Re: Boat Lifts at the Ocean Springs Harbor

SECTION 00901-02
ADDENDUM NO. 2

Project: Boat Lifts at the Ocean Springs Harbor	Owner: Mississippi Department of Marine Resources	Engineer's Project No.: 216-015
--	--	------------------------------------

MISSISSIPPI DEPARTMENT OF MARINE RESOURCES
BOAT LIFTS AT THE OCEAN SPRINGS HARBOR
ALTERNATE #2
EXTERIOR ELEVATIONS, SECTIONS & DETAILS

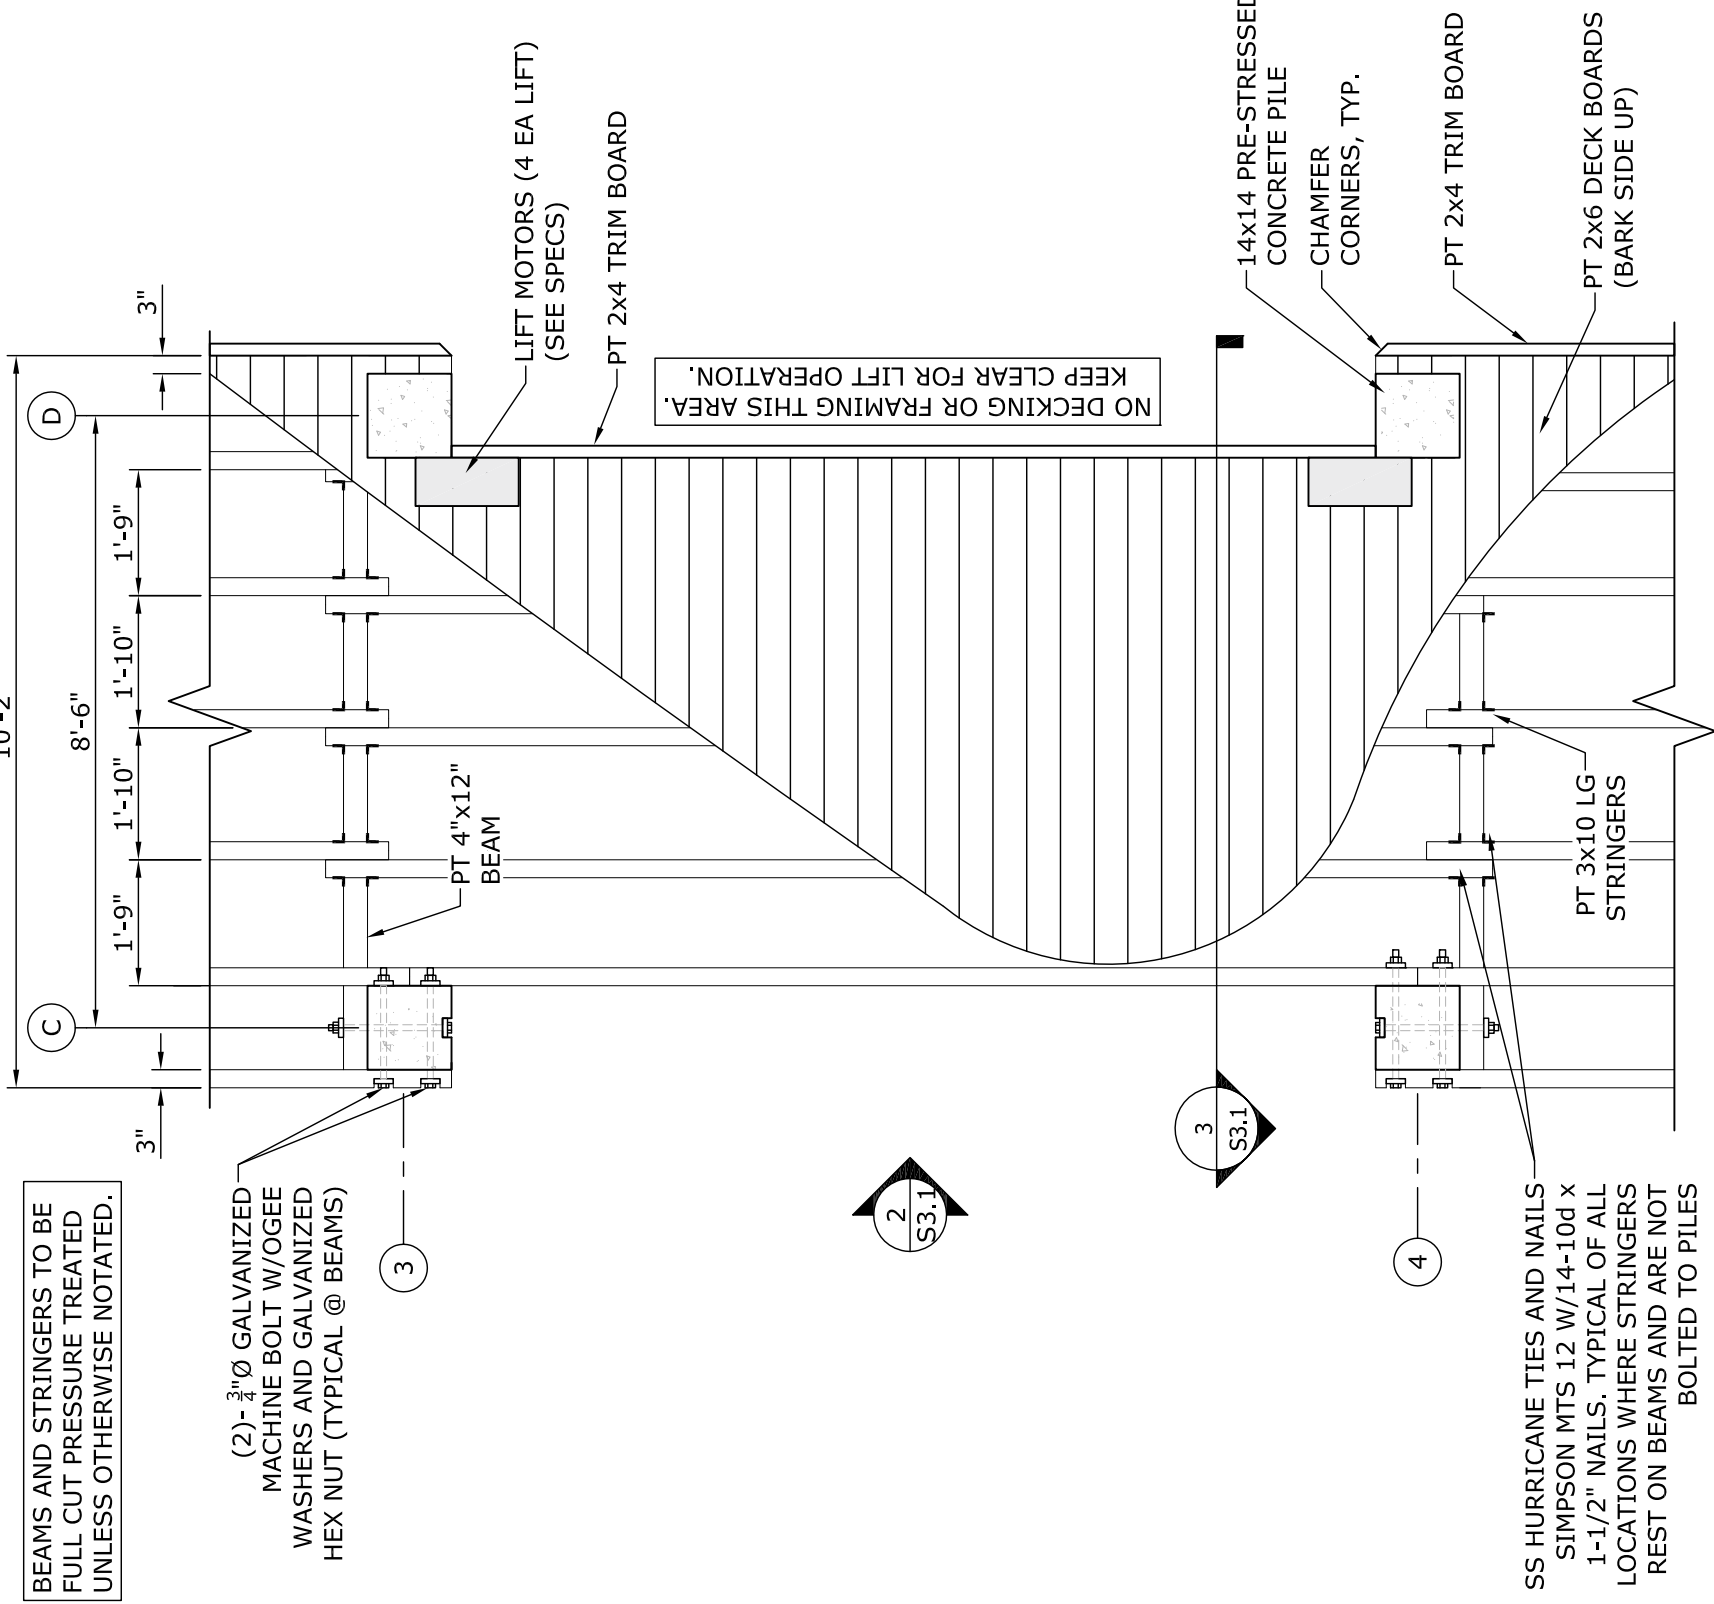
1. SHEET S2.2

Delete Sheet S2.2 in the project manual and replace with **Attachment #1 to Addendum #2.**

Notable Changes:

- a. Pile top plate is to be cast in place with Nelson Studs.
- b. Weld column plate to pile plate after driving piles.
- c. Cross-brace rods are to 1 inch diameter.
